Date: 3rd August 2017
My ref: 17/01634/PREAPP
Your ref: PRE.047/17
Please ask for: Rob Fowler
Email: rfowler@oxford.gov.uk
Direct Dial: 01865 252104

Proposal: Request for Pre-Planning application advice by the Environment Agency for the Oxford Flood Alleviation Scheme at land from North of Botley Road to New Hinksey in the parishes of North Hinksey, South Hinksey and Kennington

17/01634/PREAPP - review Oxford flood alleviation scheme

Figure 1.2 – VISSIM Network Extents

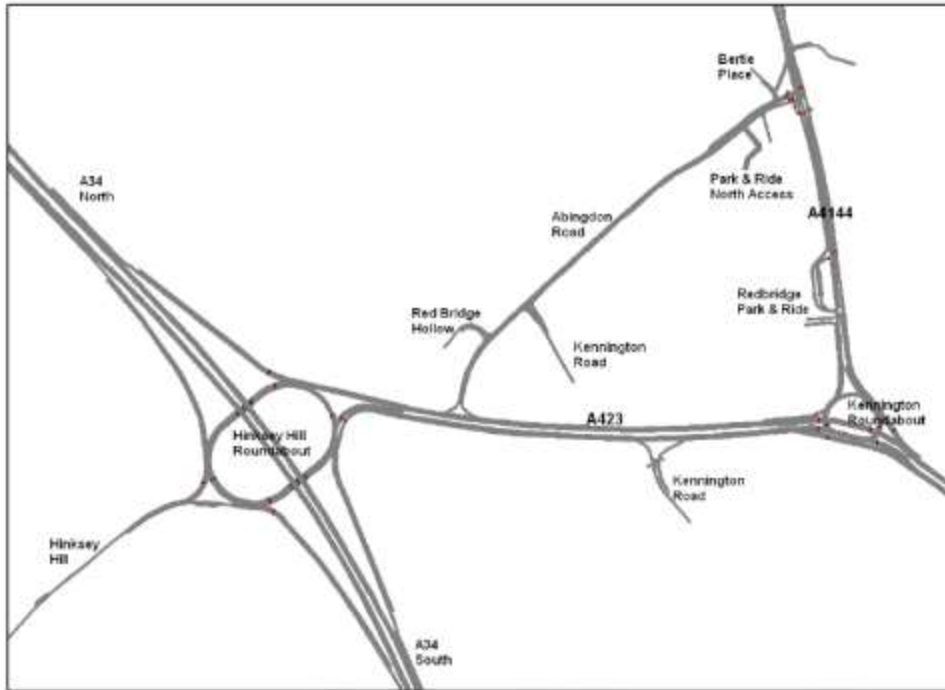
As you will see the VISSIM model for the Hinksey Hill scheme covers the area that would be affected by the Old Abingdon Road closure, therefore the use of this model to understand the impact of the closures as a result of OFAS should be considered. I will discuss this further with my colleagues in the Network Management team.
